**RE: REVISED PARKING STATEMENT FOR SMOKETREE RESORT MIXED-USE HOTEL: FEBRUARY 2025 SITE PLAN
— PARADISE VALLEY, ARIZONA**

REVIEW COMMENTS AND RESPONSES

Smoketree Resort
9th Submittal

Reviewer Name, Agency: **Paul Michaud Planning Manager Town of Paradise Valley**

1 MASTER SITE PLAN
SCALE: 1" = 20'-0"

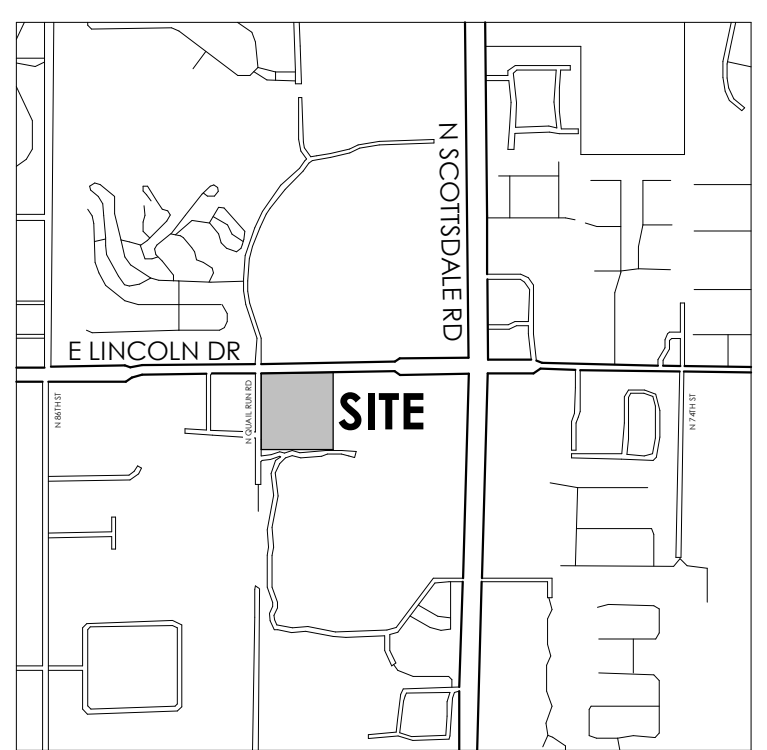
Item	Review Comment	(Code) & Response
4.	Page 19 – Attachment B Site Plan: The site plan and revised site plan detail a dining/courtyard of approximately 4,401 square feet with 116 seats. However, the shared parking study only evaluates the dining area inside the restaurant. The dining/courtyard is an extension of the restaurant’s dining area and should be included in the shared parking analysis. There is a scenario in which the interior and exterior dining areas are both at capacity. We suggest including the dining/courtyard square footage in the shared parking analysis.	(1) Analysis has been updated to include the outdoor dining area.

10.	Attachment B – Site Plan: Include a site plan for the valet operations. Where will the pick-up and drop-off zones be located? Additionally, what travel route will be used to drop vehicles off at available parking spaces? We suggest including a site plan for valet operations.	(1) A valet site plan is recommended and should be provided by the client.
